1111 NW 59th Street

STREAMLINE DESIGN REVIEW
SDCI PROJECT #3039551-EG
JUNE 1ST, 2022

3039551-EG_LandUse_CYCLE# 2 8-8-2022_Markup Summary

SITE ANALYSIS
ADJUSTMENT REQUEST

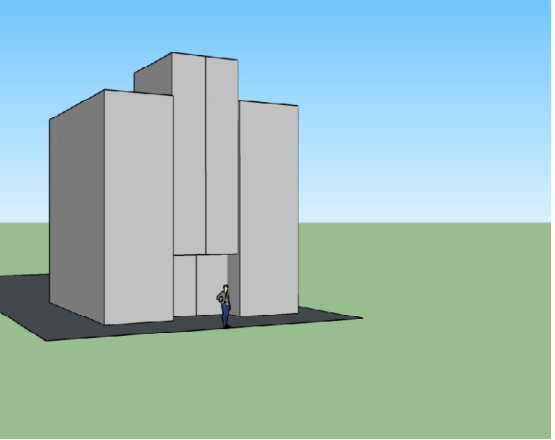
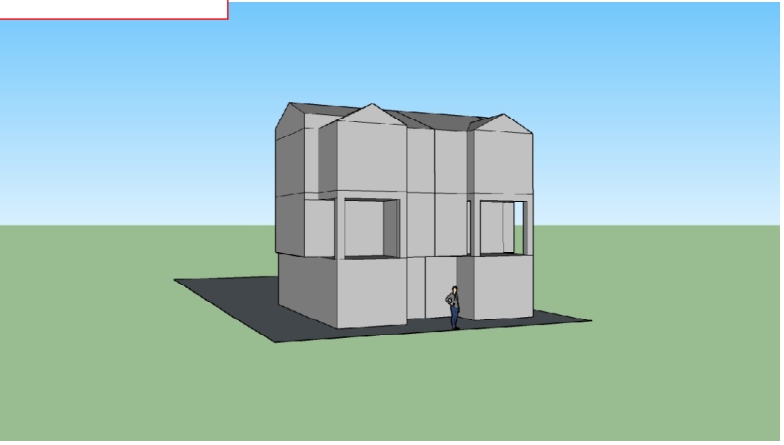
What does this number represent?

Remove the percentage references, simplify this to include the maximum allowed length (65') and the proposed adjusted length (66'7") an increase of 1'7".

Color in the increased facade length similar to the adjustment request for setbacks on page 8.

NOTE: Changes this page to information format and depictions have been made at the express request of the reviewer and is not consistent with previous direction.

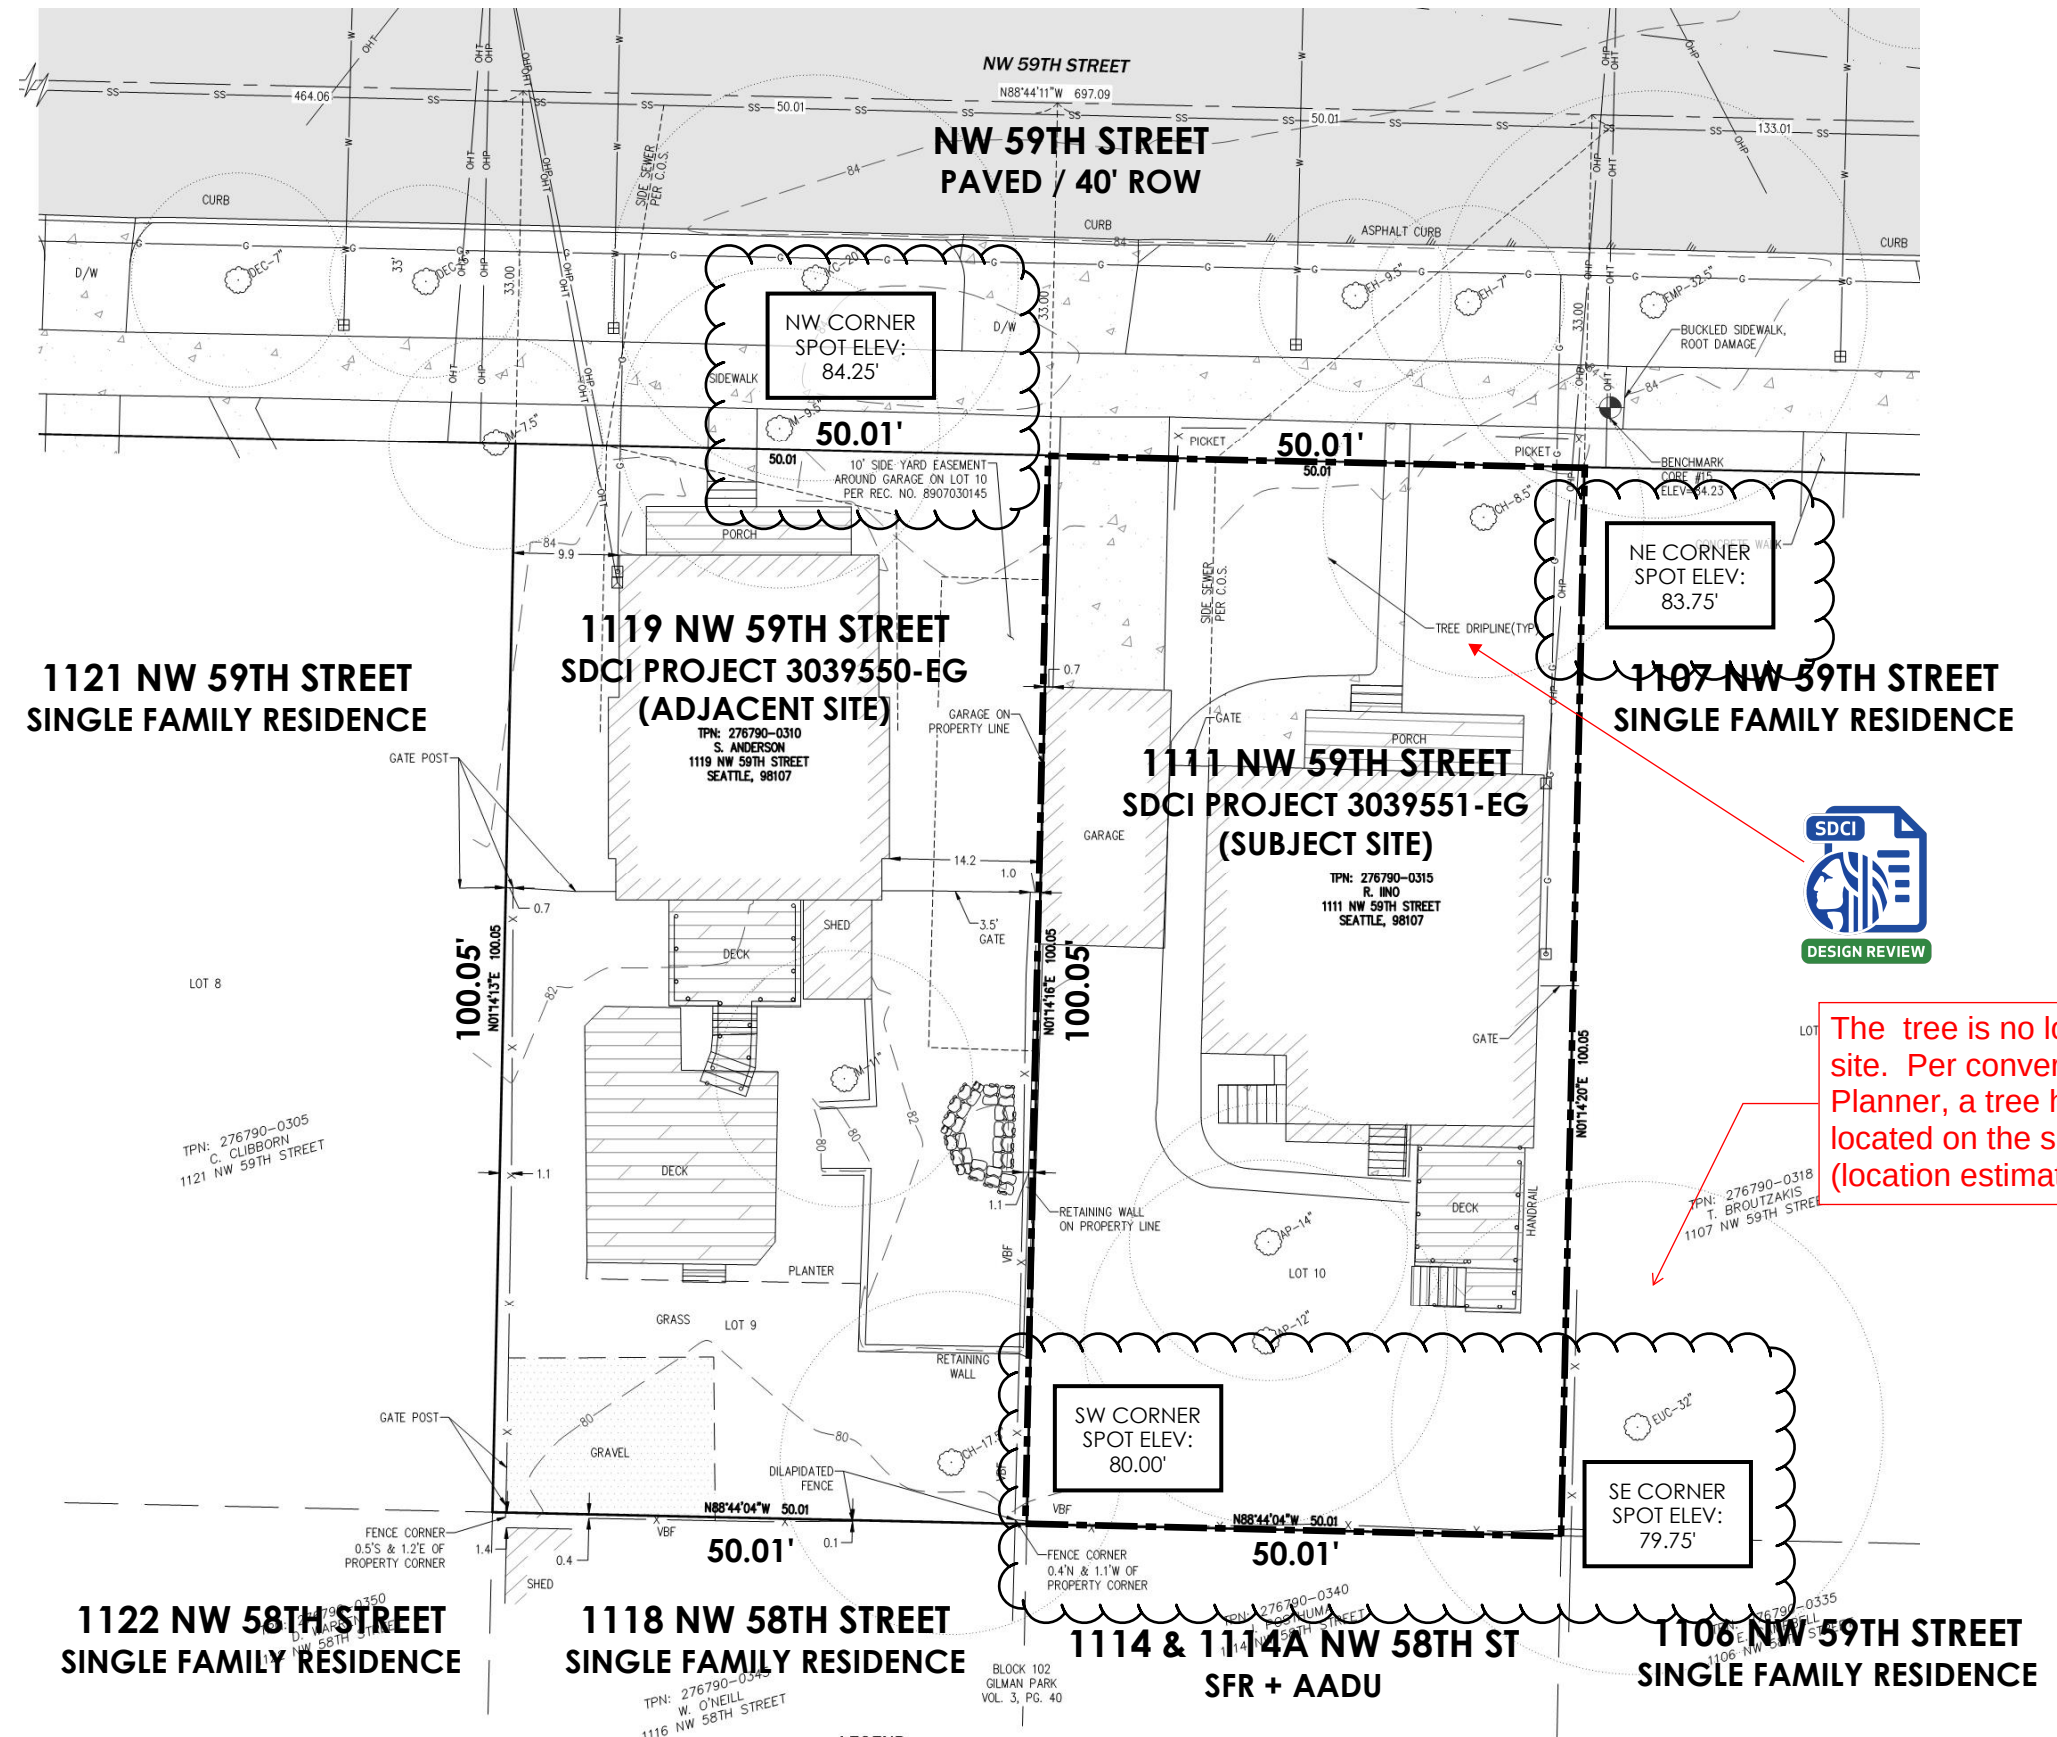
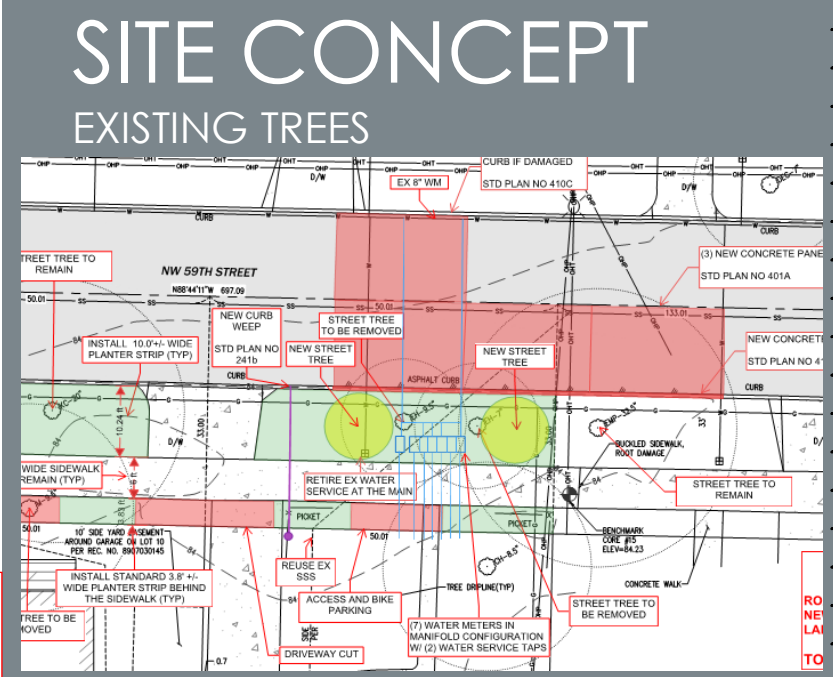
Based on the information provided in the arborist report dated December 16, 2021, an Exceptional Tree is present on the site. Show the tree location on the site plan.

Per the arborist report dated December 16, 2021, update this page and include the exceptional tree on the project site.

ON-SITE TREES 101, 102, AND 103 (NOTED
AS SIGNIFICANT, **NOT EXCEPTIONAL**) TO
REMAINBE REMOVED AS PART OF SDCI
PERMIT 6895306-CN

The tree is no longer on the site. Per
conversation with Planner, a tree has been
located on the survey (location estimated).
see added sheet demonstrating compliance
with SMC 25.11.070.2 to allow the removal of
an exceptional tree.

SITE CONCEPT

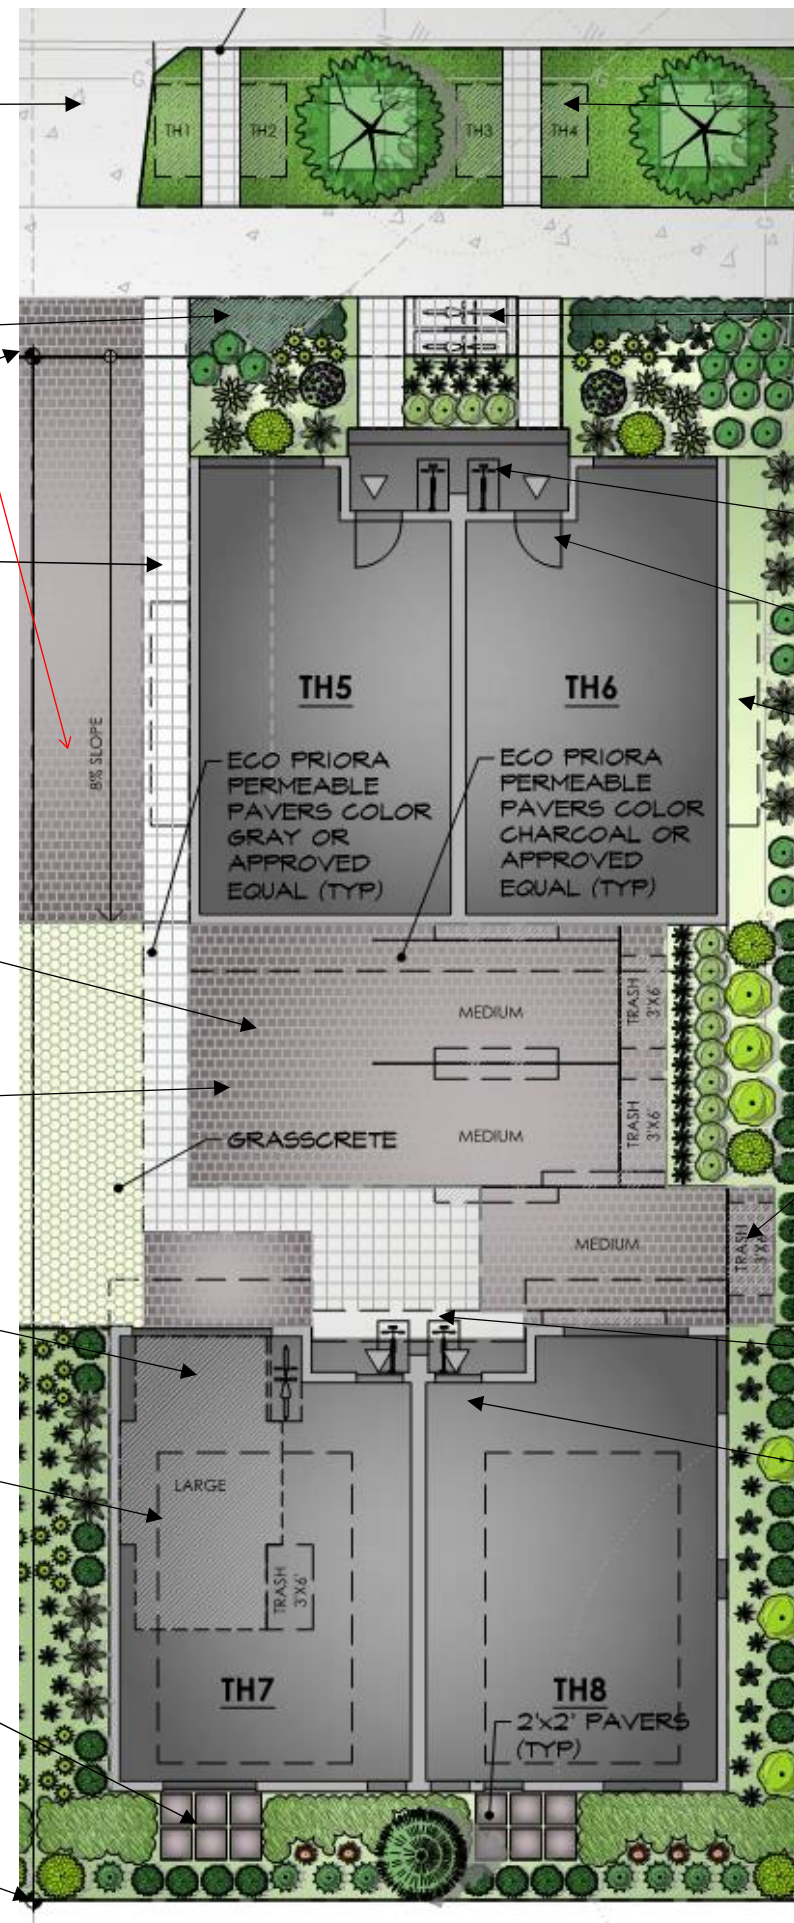
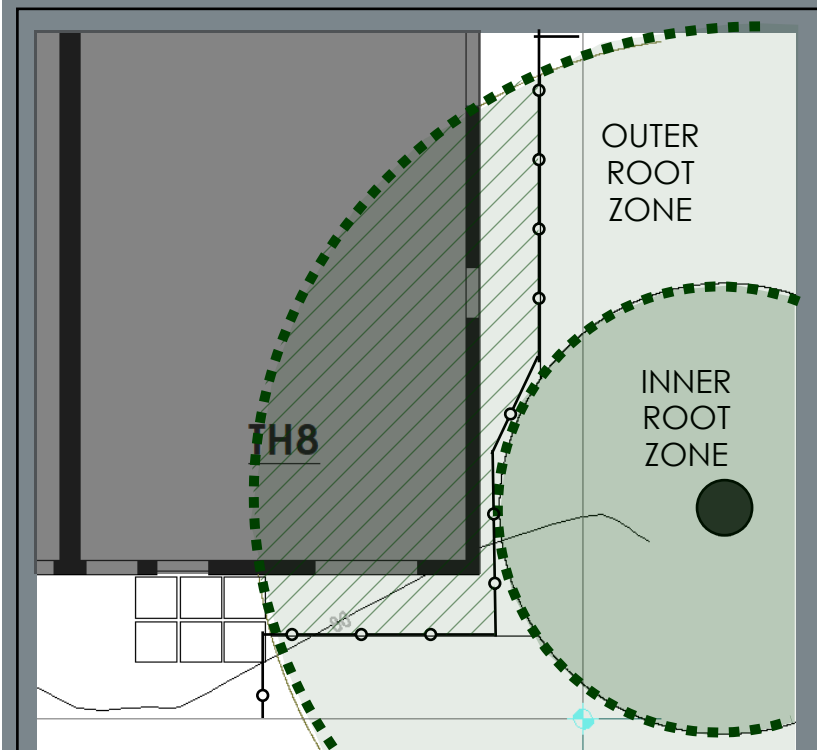
Please provide a scale for this site plan.

If the exceptional tree on the site will not be saved, please provide information per SMC 25.11.070 demonstrating the tree may be removed.

See revised site plan with graphic scale

The tree is no longer on the site. Per conversation with Planner, a tree has been located on the survey (location estimated). see added sheet demonstrating compliance with SMC 25.11.070.2 to allow the removal of an exceptional tree.
